THE MARTLETS SHOPPING CENTRE REDEVELOPMENT: PROPOSED HIGH1WAY WORKS

Project: The Martlets Shopping Centre Redevelopment; Proposed Highway Works

Report Title: Stage 1 Road Safety Audit

Road Safety Audit Response Report

title PROPOSED HIGHWAY IMPROVEMENTS		
scale 1:500	drawn by T.A.S	checked by R.H.L
date APRIL 2025		status PLANNING
drawing number 14091 - 012		rev. H

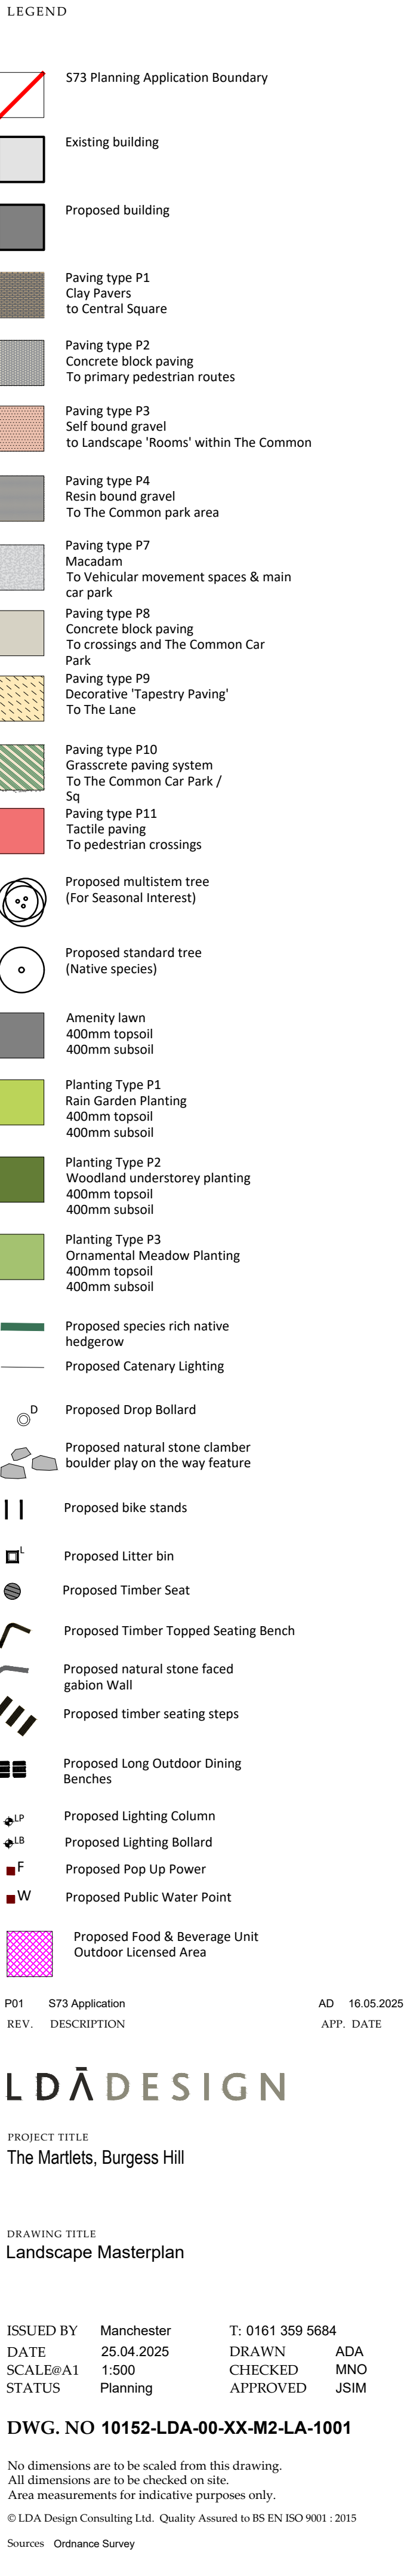
2.2 After due and careful consideration no issues have been identified in terms of highway road safety from the information provided on this drawing at this Stage of Audit. See also Comments 3.1 and 3.2.

- 3.1 The proposed access is relatively close to the Lower Church Road roundabout junction and there is the potential for vehicles turning right to the car park / delivery area to be blocked by any queue that develops on the approach to the roundabout. In the opinion of the audit team the potential for collisions resulting in personal injury is low as a direct result of this effect, however, it would be beneficial to introduce a “KEEP CLEAR” carriageway marking to protect the access and facilitate movement as the scheme is progressed to detailed design, as has been provided on the approach to the southern roundabout.

- 3.2 Due to the proximity of the access to the Civic Way roundabout there is the potential for drivers seeking to turn right to use the roundabout to facilitate the right turn, thereby removing the direct right turn from the car park access. It would be beneficial to seek the views of the highway authority on this based on simplification of vehicle movement rather than road safety grounds

3.1 The proposed access is relatively close to the Lower Church Road roundabout junction and there is the potential for vehicles turning right to the car park / delivery area to be blocked by any queue that develops on the approach to the roundabout. In the opinion of the audit team the potential for collisions resulting in personal injury is low as a direct result of this effect, however, it would be beneficial to introduce a "KEEP CLEAR" carriageway marking to protect the access and facilitate movement as the scheme is progressed to detailed design, as has been provided on the approach to the southern roundabout.	"KEEP CLEAR" markings will be added at the detailed design stage

3.2 Due to the proximity of the access to the Civic Way roundabout there is the potential for drivers seeking to turn right to use the roundabout to facilitate the right turn, thereby removing the direct right turn from the car park access. It would be beneficial to seek the views of the highway authority on this based on simplification of vehicle movement rather than road safety grounds.	The views of the West Sussex County Council will be obtained as part of the application. No comments in relation to this was raised at the pre-app stage.

date MAY 2025	drawn by C.P	checked by R.H.L
scale 1:500	status PLANNING	
drawing number 19085 - TR017	rev.

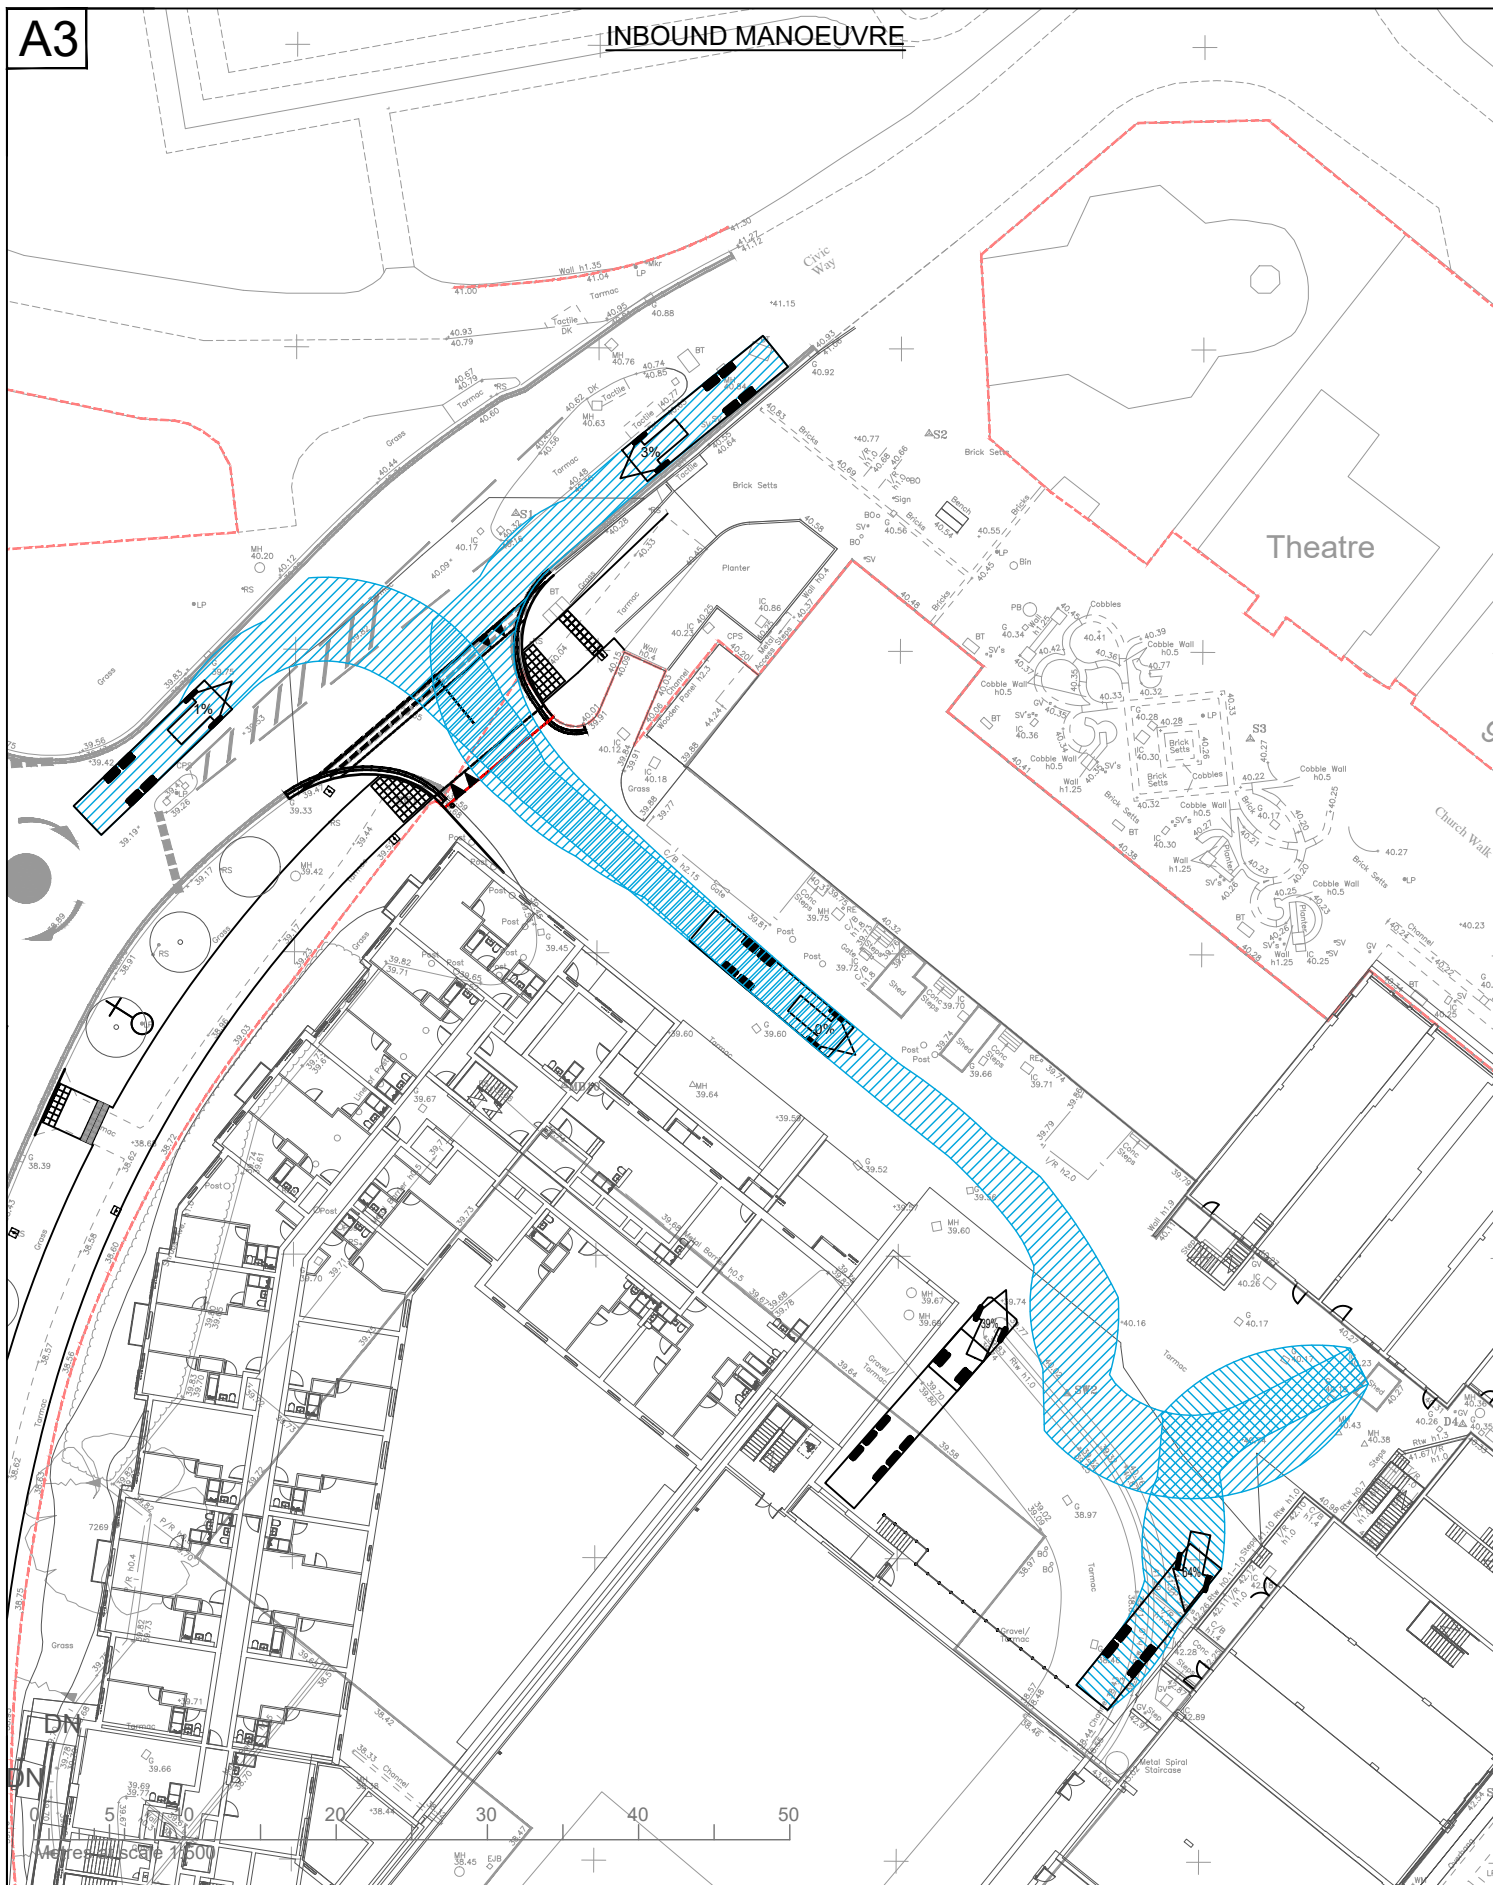
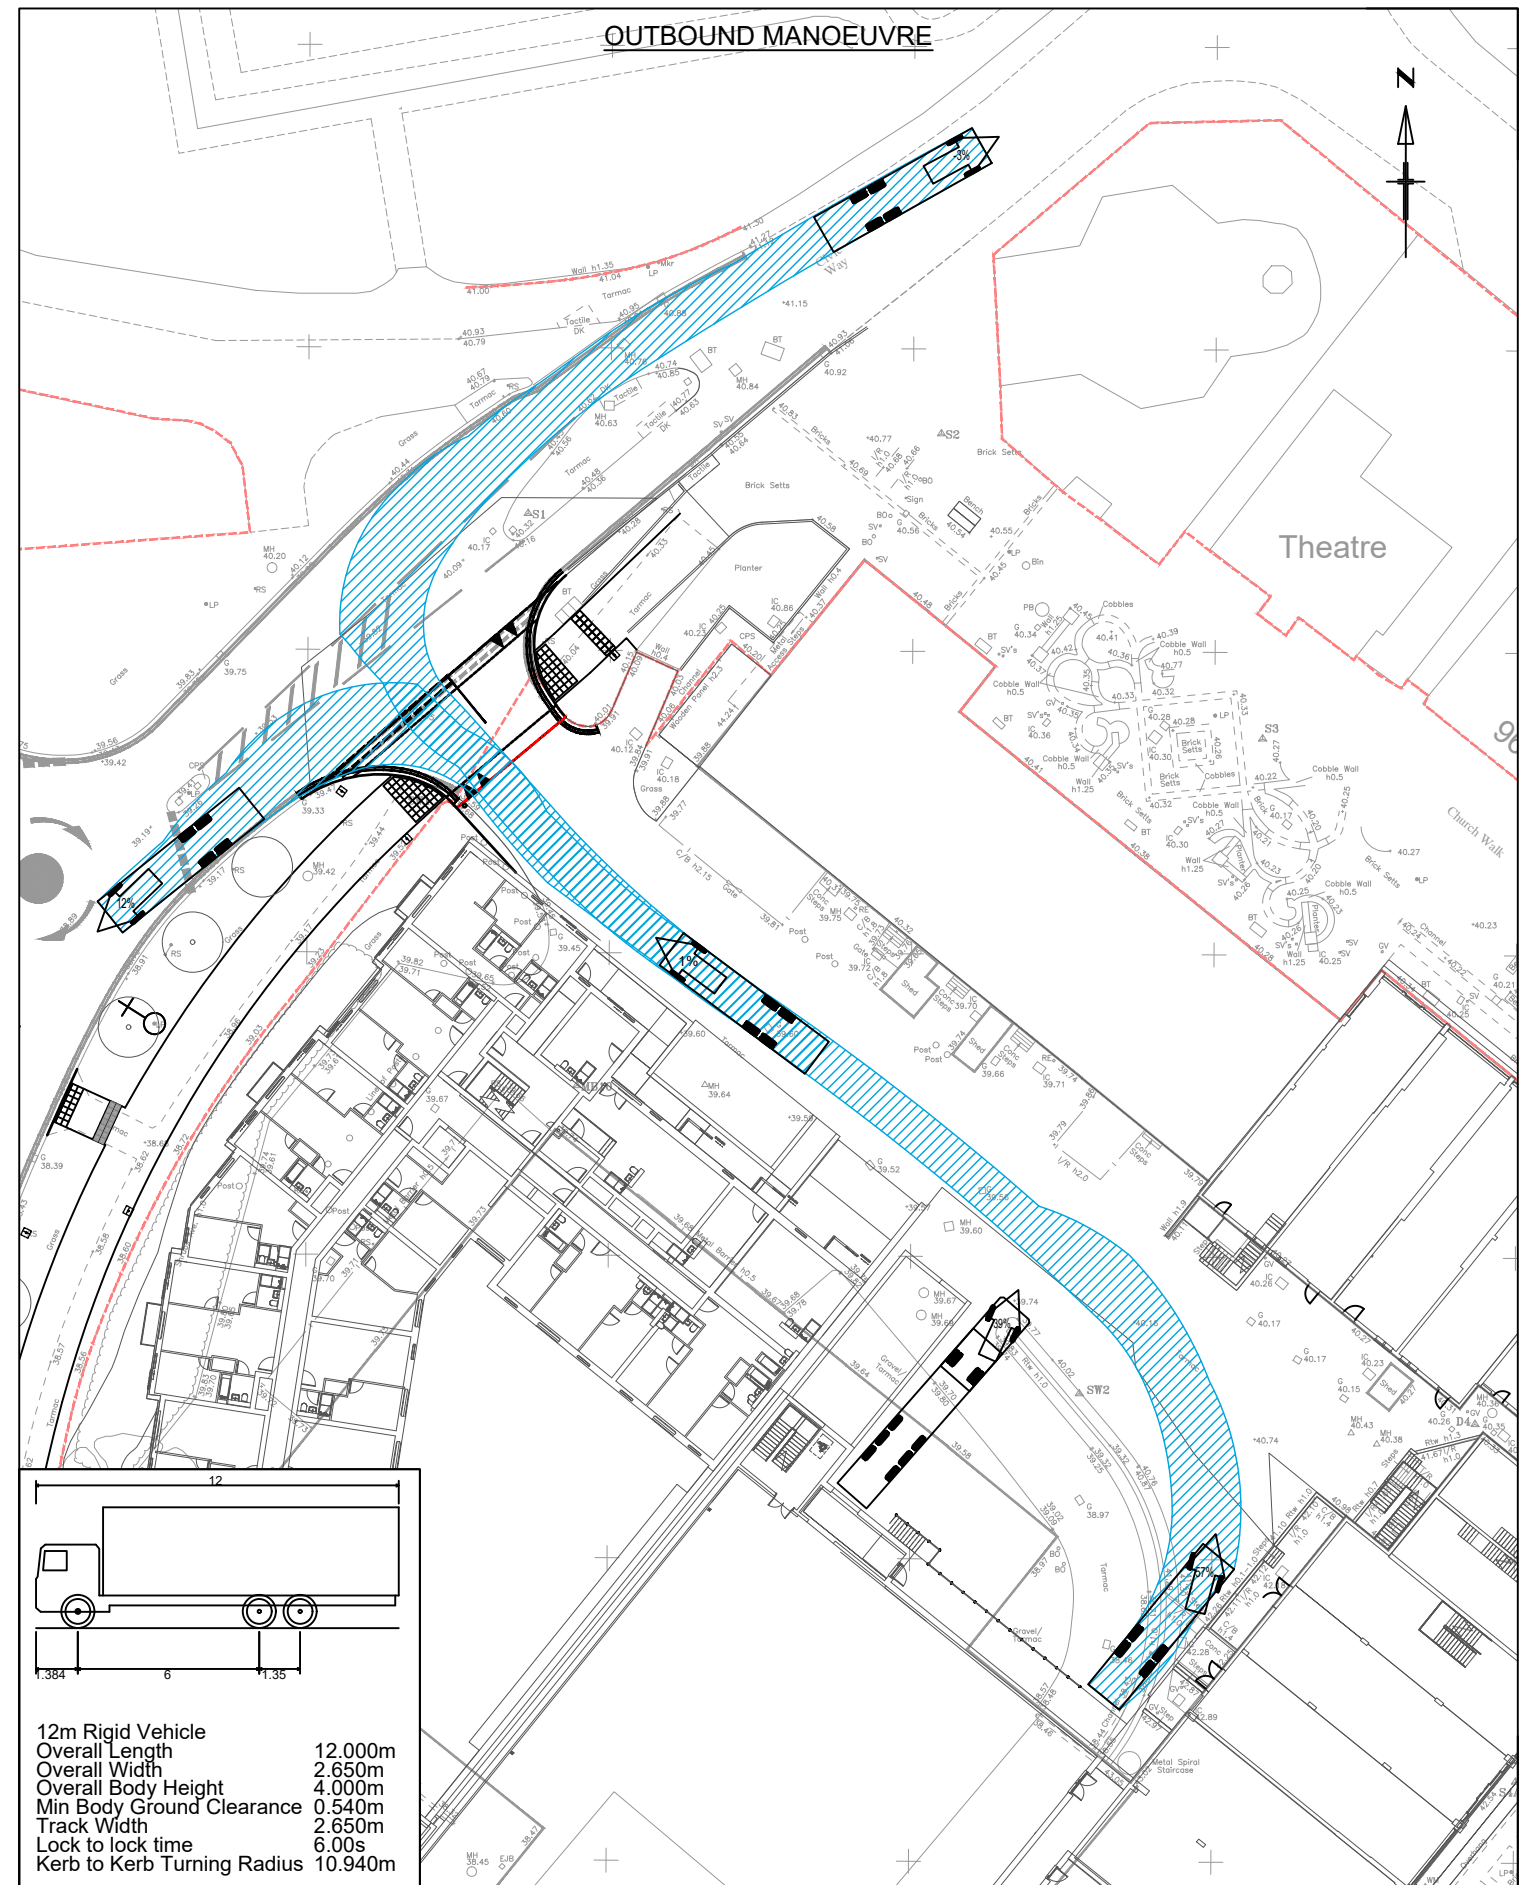
2.8 The drawing shows the swept path movements for a 12m rigid lorry accessing the hotel loading area. All movements are contained within the available carriageway space with only minor incursion within the hatched area for the left turn out, and as such does not give rise to concern in terms of road safety.

19085-SK250401.3 Rev (Now TR017) The drawing shows the swept path movements for a 12m rigid lorry accessing the hotel loading area. All movements are contained within the available carriageway space with only minor incursion within the hatched area for the left turn out, and as such does not give rise to concern in terms of road safety.	NA	NA	NA	NA
19085-SK250401.1 Rev (Now TR019) The drawing shows the swept path movements for a FTA Design Articulated Vehicle (2016) accessing the retail loading area. All movements are contained within the available carriageway space with only minor incursion within the hatched area for the left turn out, and as such does not give rise to concern in terms of road safety.	NA	NA	NA	NA
19085-SK250401.2 Rev (Now TR018) The drawing shows the swept path movements for a FTA Design Articulated Vehicle (2016) accessing the retail loading area. All movements are contained within the available carriageway space with only minor incursion within the hatched area for the left turn out, and as such does not give rise to concern in terms of road safety. The swept path movements only differ from that considered under paragraph 2.9 above in the final loading bay accessed, movements to the highway network remain the same between the two drawings.	NA	NA	NA	NA
